Technical Service Bulletin

MODEL(S) AFFECTED: **Tennant S20 machines equipped with plastic hoppers (Serial Numbers 000000 through 001070)**

SUBJECT: Loss of vacuum due to seal broken between the cyclone tray and the hopper top lip.

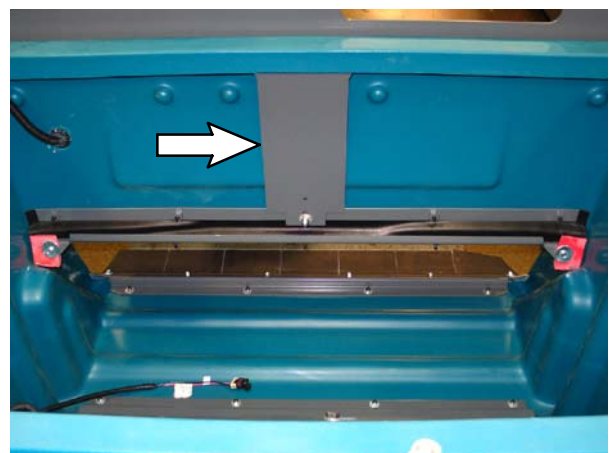
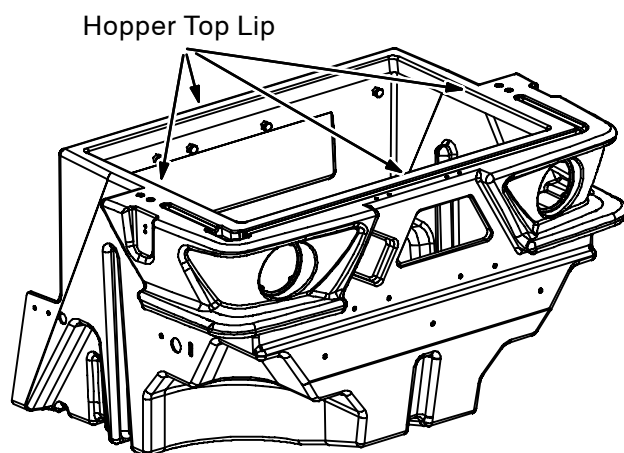
NOTES: Inspect the hopper top lip for warping / flexing that could cause the hopper / cyclone tray to lose vacuum.

PURPOSE: Install the hopper support kit to provide additional support to the hopper top lip.

Order kit #9007153 Hopper Kit, Repair. The IB for this kit is 9007158. Refer to the IB for instructions how to install the hopper lip supports.
